Products: CP2500 Series

Please be informed that the resistance board used for the models above mentioned will be changed due to the discontinuation of the material. Please find the details below. Your understanding and cooperation would be appreciated.

変更箇所詳細

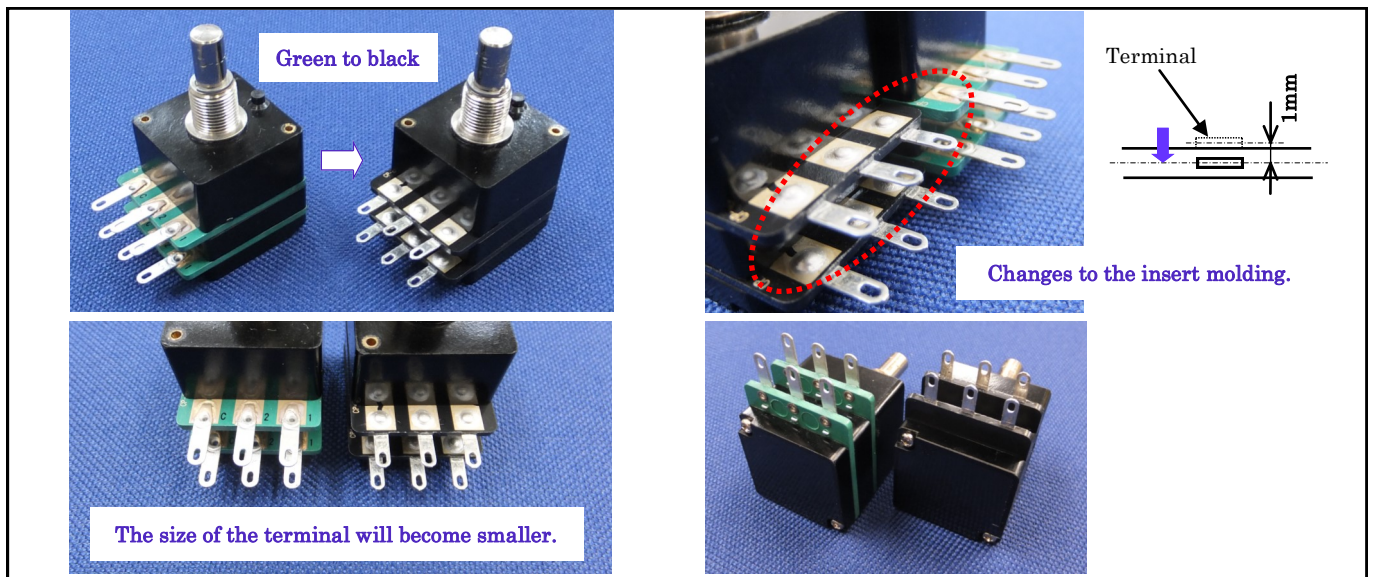
- * The color of resin for the resistance board will be changed from green to black.
- * There is no change in the electrical specification.
- * The position of the terminals will be moved 1mm.
(Please refer to the pictures below.)
- * The size of the terminal will become smaller.
(7.5mm→6mm length, 3mm→2.5mm width)
